R66 SERVICE BULLETIN SB-18

SUBJECT: MRGB Output Yoke Retaining Plug

ROTORCRAFT AFFECTED: R66 Helicopters S/N 0004 thru 0707.

FIGURE 1

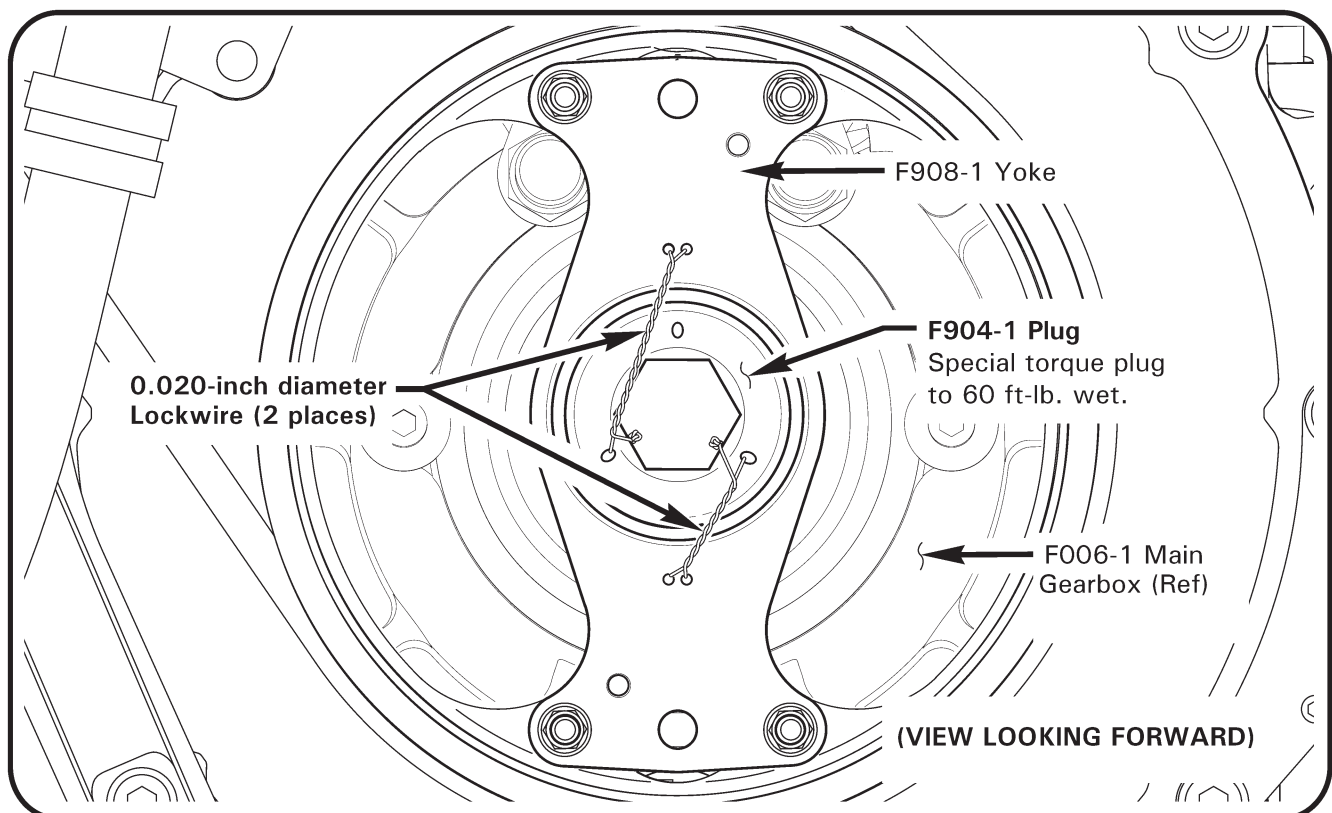
BACKGROUND: RHC has received reports of a loose F904-1 plug, which secures the F908-1 yoke to the main gearbox. The yoke experiences higher loads on helicopters with air conditioning due to belt tension which may cause the plug to loosen. This bulletin requires increasing the plug torque and installing additional lockwire.

4. Refer to Figure 1. Set rotor brake. Remove and discard lockwire securing F904-1 plug to yoke and remove plug using a 3/4-inch hex-bit socket. Visually inspect forward C947-3 flex plate assembly and plug for damage. Order replacement parts from [RHC Customer Service](#) if damage is found.

5. Apply light coat of A257-9 anti-seize to plug threads, install plug in gearbox, and special torque plug to 60 ft-lb wet.
6. In two places, install 0.020-inch diameter lockwire and safety plug to yoke with pigtailed inside recess of plug as shown.
